Publication 72M  
June 2010 Edition  
Change No. 1

**Standards for Roadway Construction, RC 1M-100M  
June 2010 Edition  
Change No. 1**

STANDARDS FOR ROADWAY CONSTRUCTION  
SERIES RC-1M TO 100M

PDT Pub #72M

**OVERLAY TRANSITIONS  
AND  
PAVING NOTCHES**

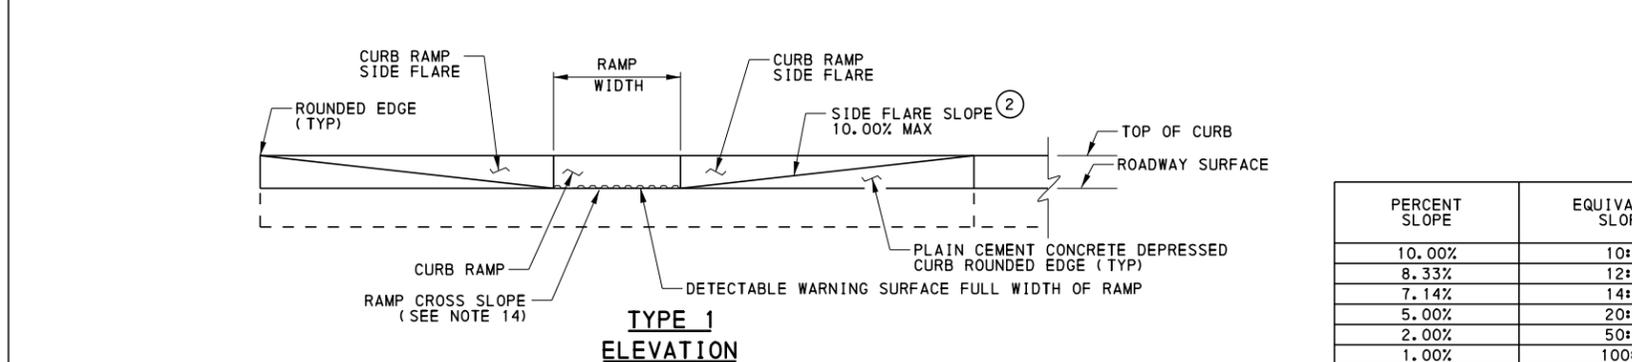
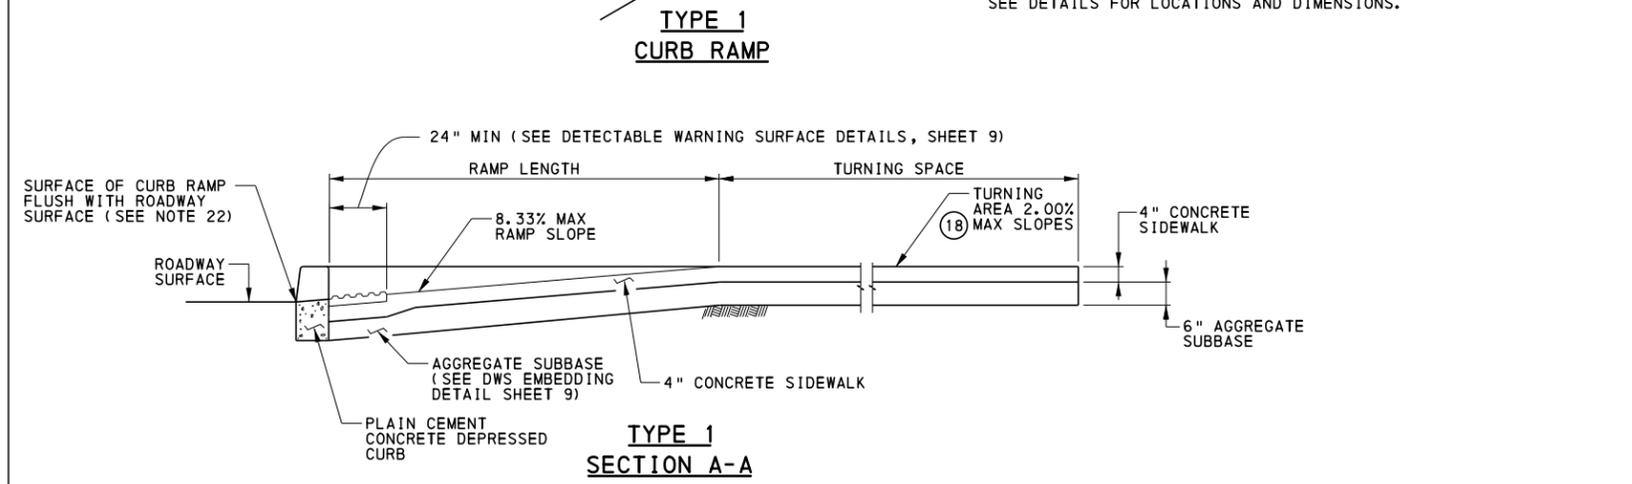
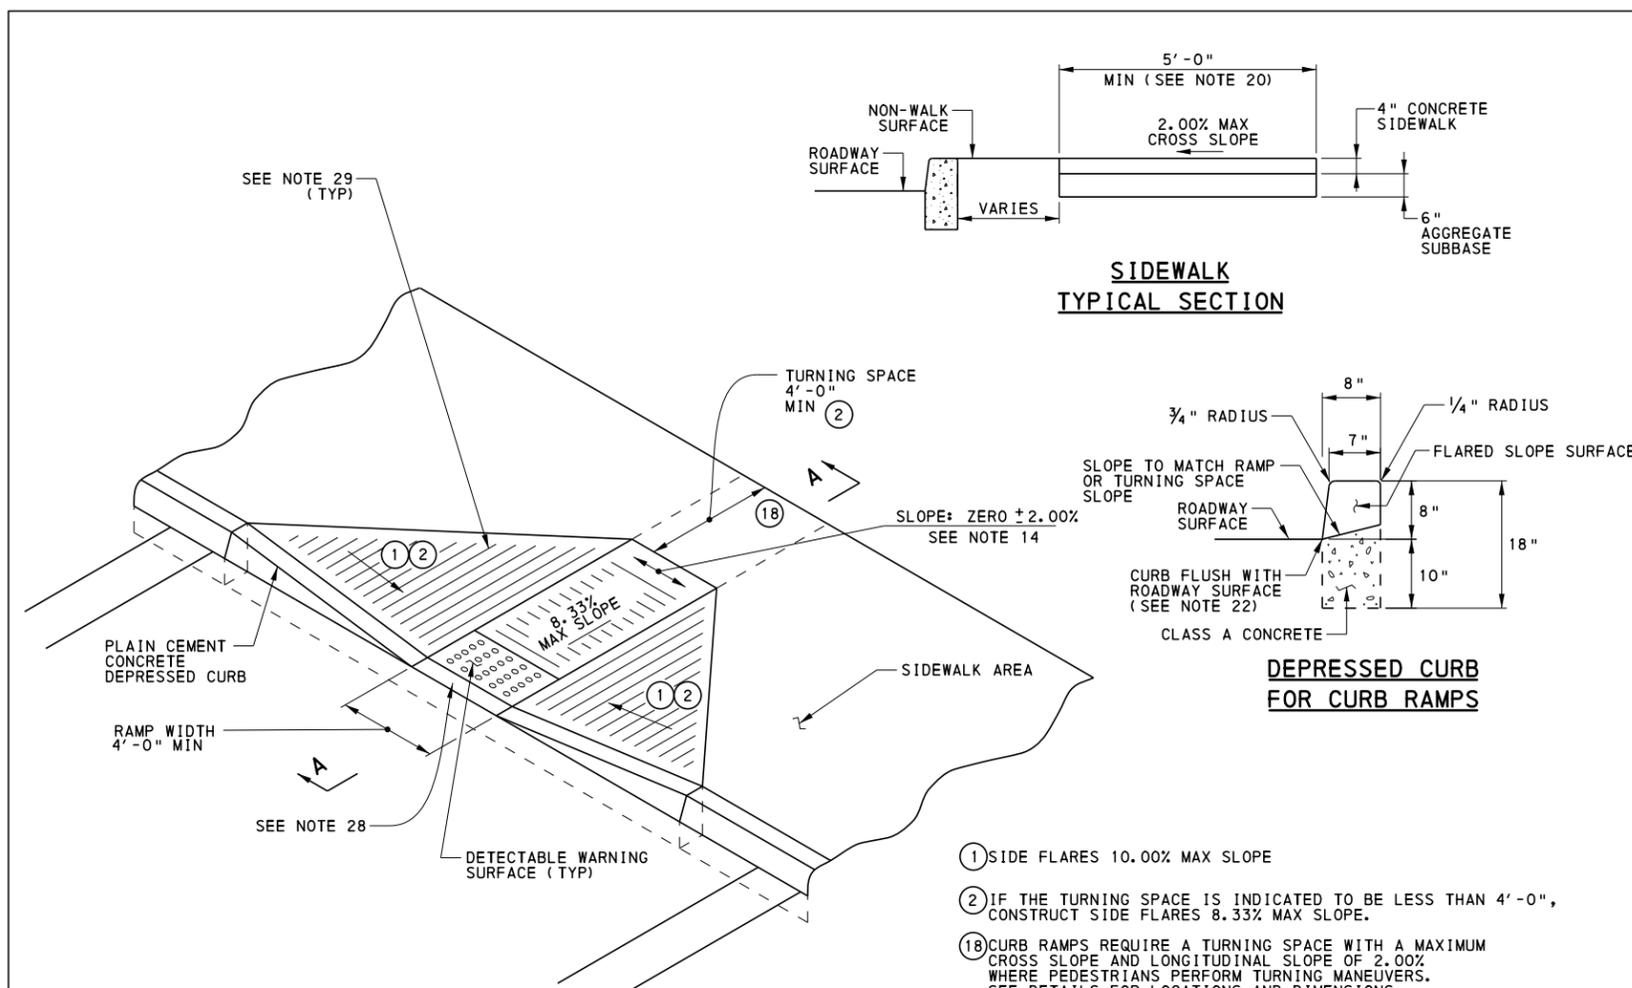
STANDARD	SHEET	DESCRIPTION OF CHANGES
RC-28M	Sheet 1	Removed metric dimensions.  In Overlay Transition with Paving Notch on Concrete and Bituminous Pavements detail, added vertical dimension to indicate milling of bituminous or concrete pavement surface, variable depth and that the variable depth milling is incidental to the paving item.
RC-67M	General	Removed metric dimensions.  Updated Notes (numbers with circles around them). See specific Sheets below for additional information.  Changed "LANDING" to "TURNING SPACE".  Added "SEE SHEET 8 FOR DETAILS" in multiple locations where pedestrian pushbuttons are applicable.
RC-67M	Sheet 1	Modified title from "TYPE 1 TYPICAL SECTIONS" to "TYPE 1 CURB RAMPS AND TYPICAL SECTIONS".  Modified Note 18 under Notes 1 and 2.  For Type 1 Curb Ramp detail, added "SEE NOTE 29 (TYP)" with callout of side flares.  For Type 1, Section A-A detail:

NEW CONSTRUCTION OR  
ALTERATION DETAILS  
TYPE 1 AND TYPE 1A CURB RAMPS

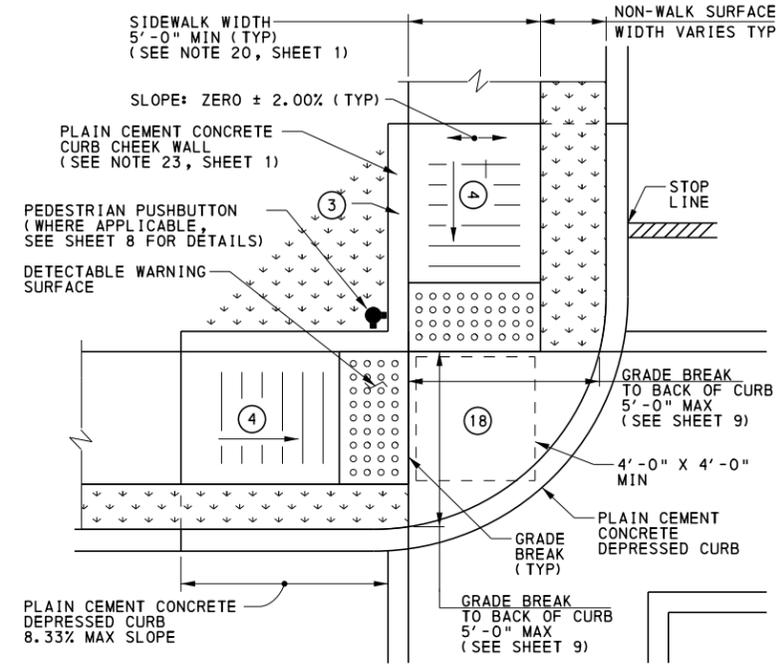
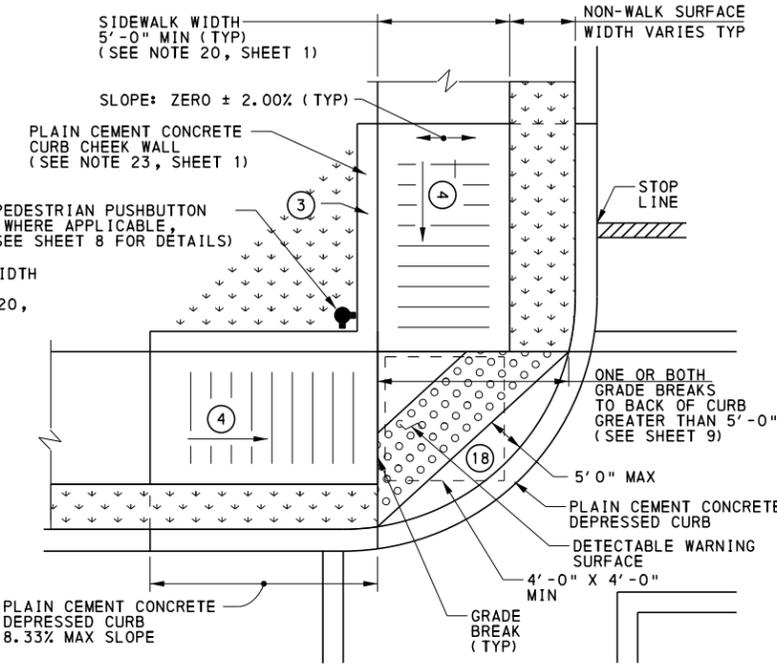
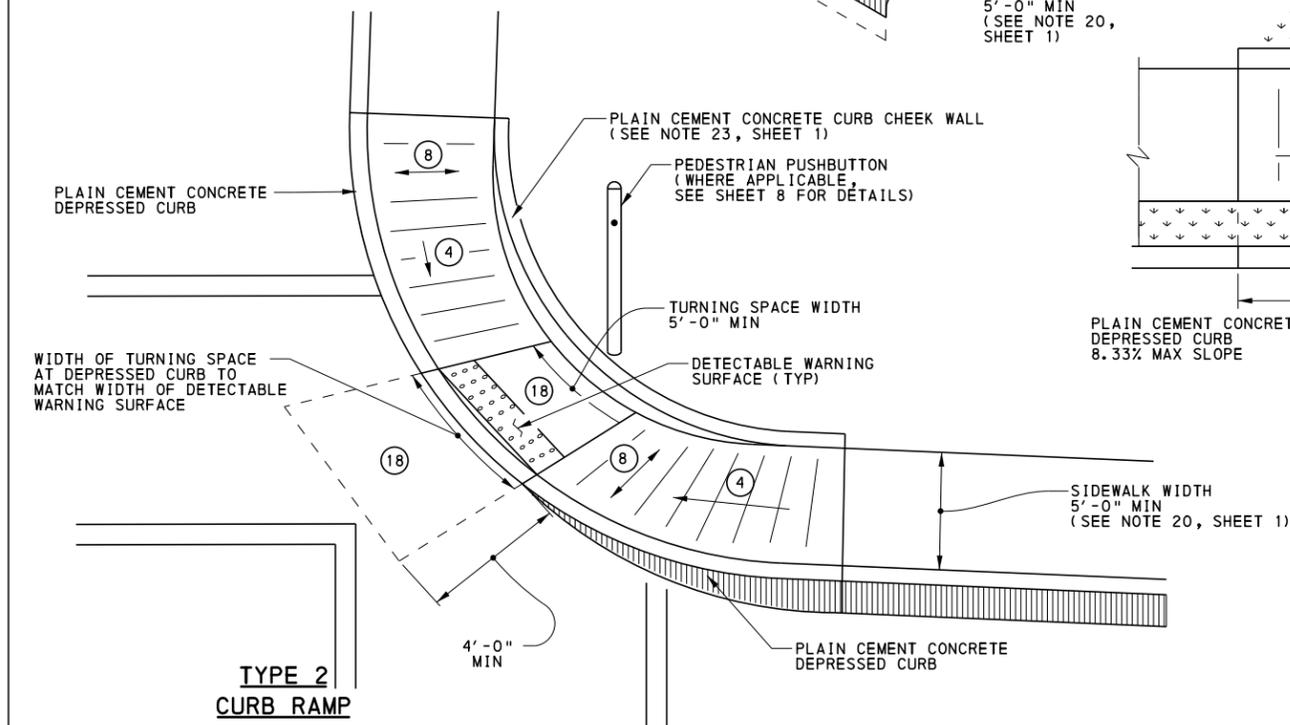
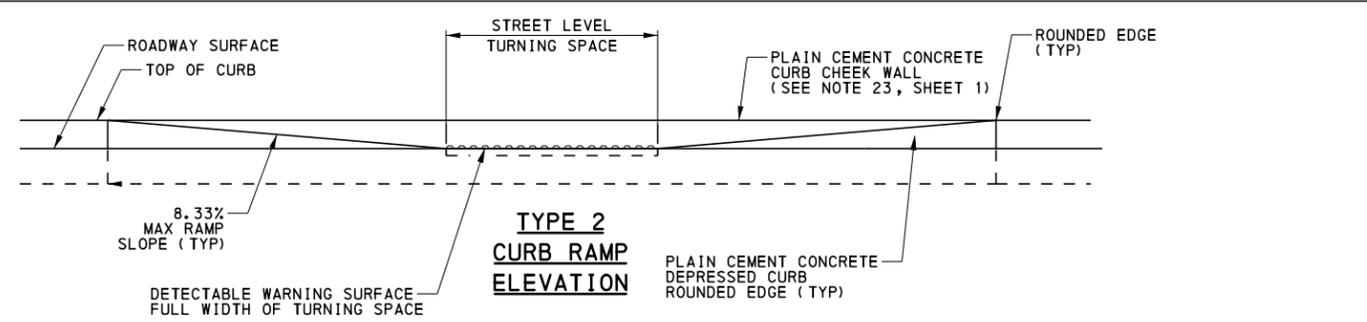
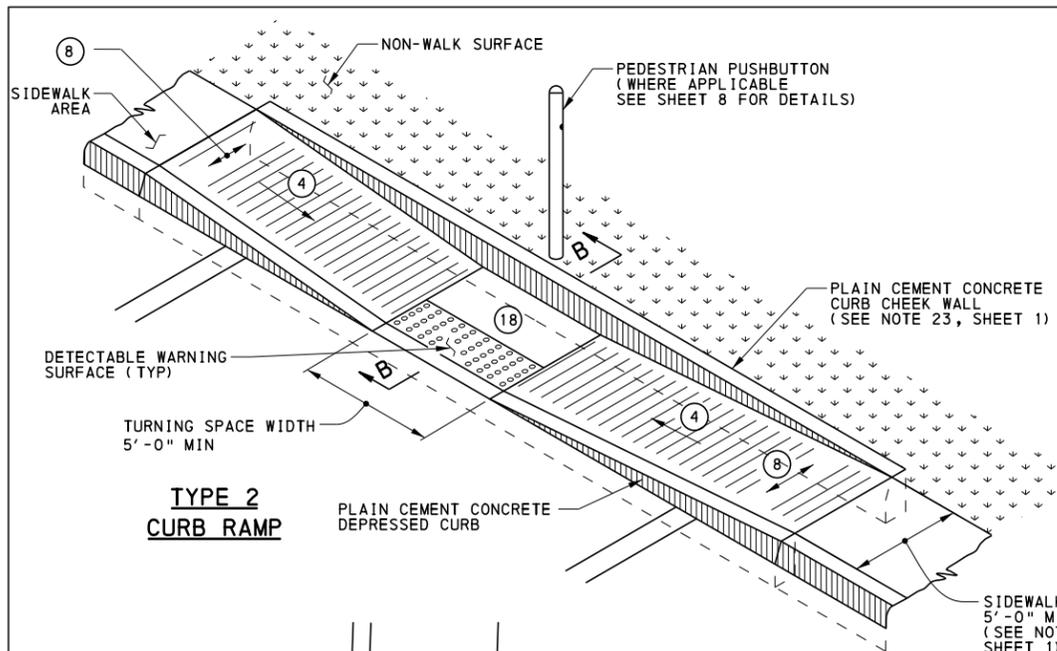
RC-67M Sheet 2

Modified title from "TYPE 1 CURB RAMPS" to "TYPE 1 AND TYPE 1A CURB RAMPS".

For Type 1A Curb Ramp detail:

\*Replaced "8.33% MAX. SLOPE" for ramp slope with Note 4.

\*Relocated vertical pavement marking for crosswalk to appear on the left of "GRADE BREAK".

Added Note 4.

Modified Note 18.

NEW CONSTRUCTION OR ALTERATION DETAILS  
**TYPE 1A AND TYPE 2 CURB RAMPS**

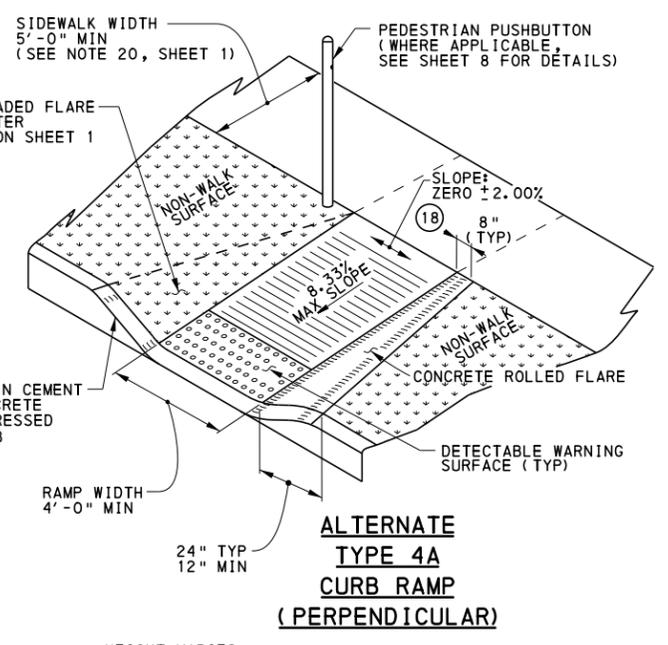
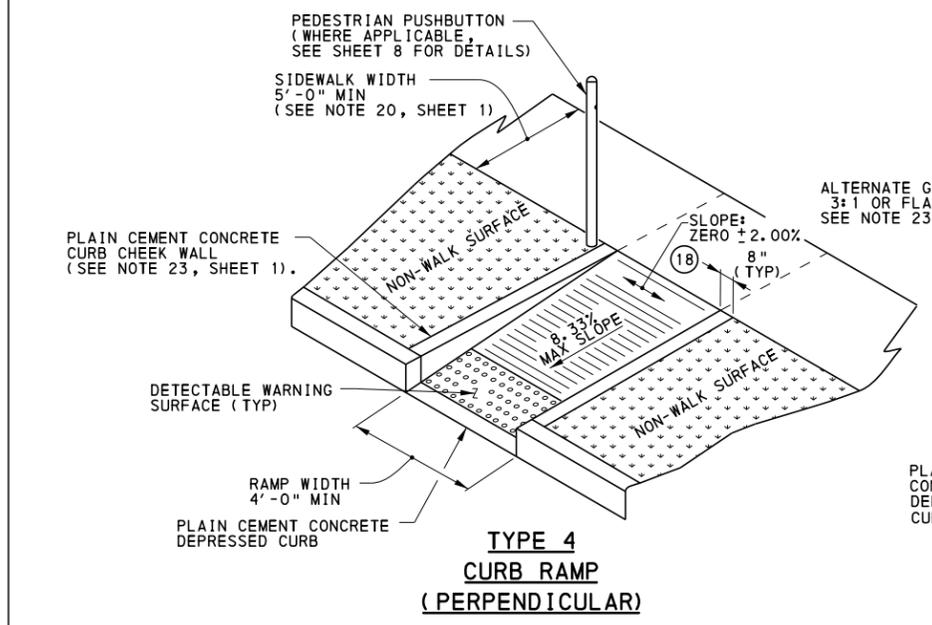
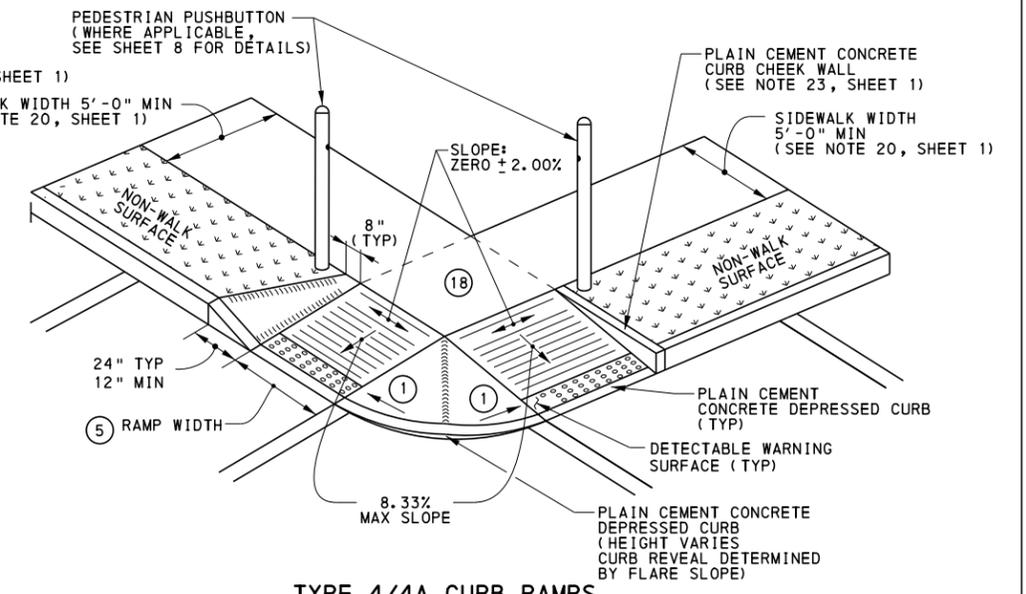
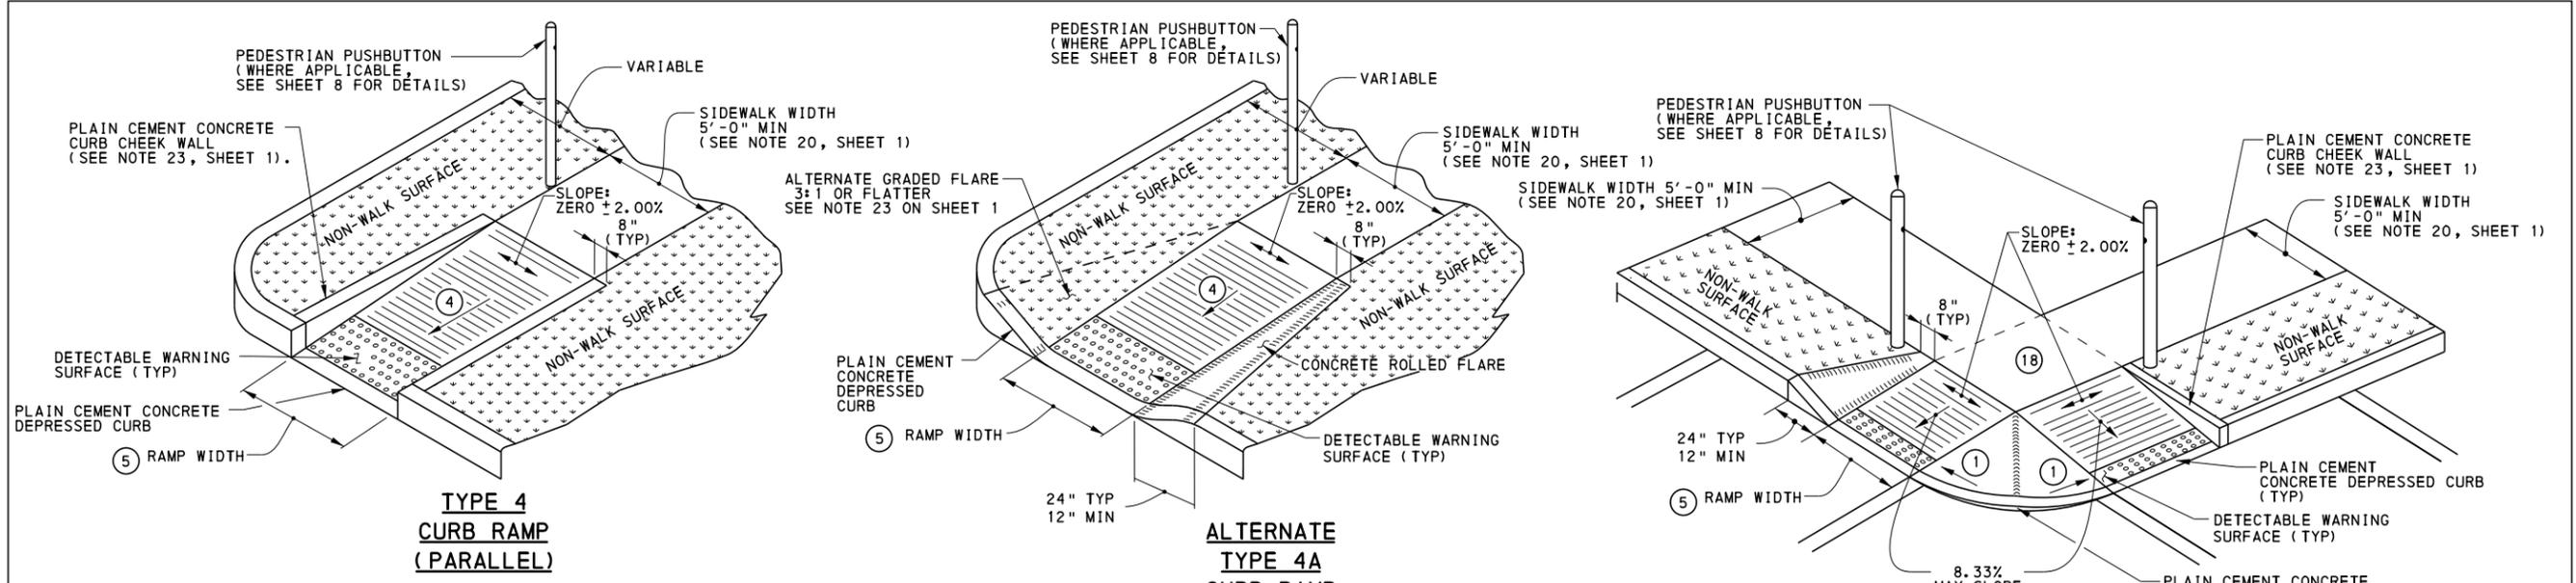
RC-67M Sheet 3

Modified title from "TYPE 2 AND TYPE 3 CURB RAMPS" to "TYPE 1A and TYPE 2 CURB RAMPS".

Deleted Type 3 Curb Ramp detail.

Added new Type 1A Curb Ramp detail with Assistant District Executive approval required if turning space is not entirely on sidewalk.

For Type 2 Curb Ramp Section B-B detail, changed "SLOPED RAMP" to "SLOPED RAMP/CURB CHEEK WALL".

Deleted Note 1.

**CURB RAMPS AND SIDEWALKS**  
 NEW CONSTRUCTION OR  
 ALTERATION DETAILS  
 TYPE 4 CURB RAMPS AND  
 TYPICAL ELEVATIONS

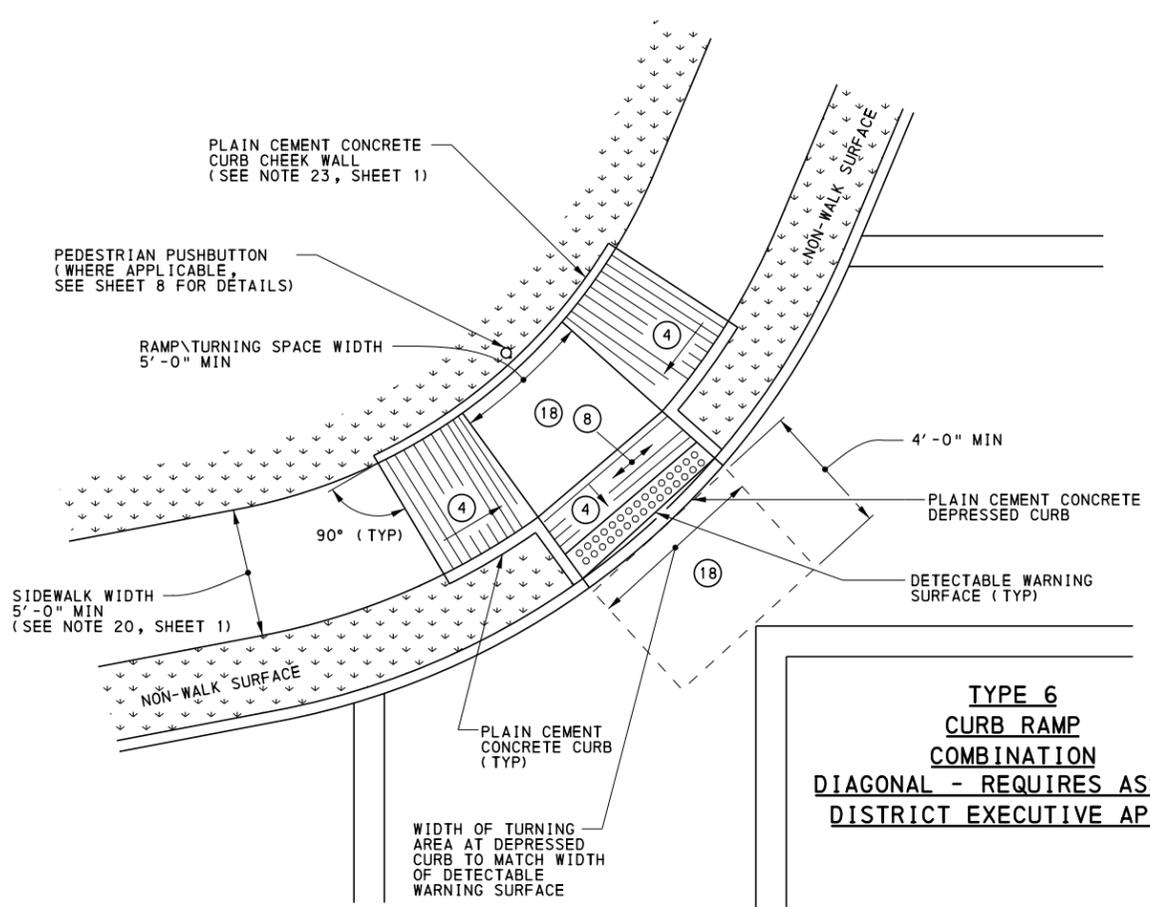
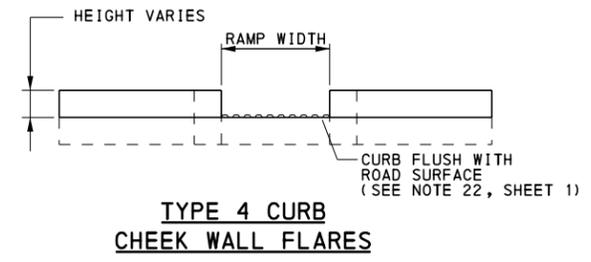
RC-67M	Sheet 4	<p>Added Note 3.</p> <p>Modified Notes 4 and 18.</p> <p>Added "AND TYPICAL ELEVATIONS" after "TYPE 4 CURB RAMPS" in title.</p> <p>For Type 4 Curb Ramp (Parallel) and Alternate Type 4A Curb Ramp (Parallel) details:</p> <ul style="list-style-type: none"> <li>*Replaced "8.33% MAX SLOPE" with Note 4.</li> <li>*Relocated pedestrian pushbutton farther away from ramp slope.</li> </ul> <p>For Alternate Type 4A Curb Ramp details:</p> <ul style="list-style-type: none"> <li>*Replaced "ROUNDED CONCRETE SURFACE" with "CONCRETE ROLLED FLARE".</li> <li>*Modified on the outside of one side of ramp to indicate "ALTERNATE GRADED FLARE, 3:1 OR FLATTER, SEE NOTE 23 ON SHEET 1".</li> </ul> <p>For Type 4/4A Curb Ramps with Shared Turning Space detail, replaced Note 4 with "8.33% MAX SLOPE".</p> <p>For Typical Elevations for Depressed Curbs details:</p> <ul style="list-style-type: none"> <li>*Changed "TYPE 4 CURBED FLARE TRANSITION" to "TYPE 4 CURB CHEEK WALL FLARES".</li> <li>*Changed "TYPE 4A NON-TRAVERSABLE ROLLED FLARE TRANSITION" to "TYPE 4A NON-TRAVERSABLE ROLLED FLARES".</li> <li>*Changed "COMBINATION TRANSITION" to "COMBINATION FLARES".</li> <li>*Added "(SEE NOTE 22, SHEET 1)" after "CURB FLUSH WITH ROAD SURFACE".</li> </ul>
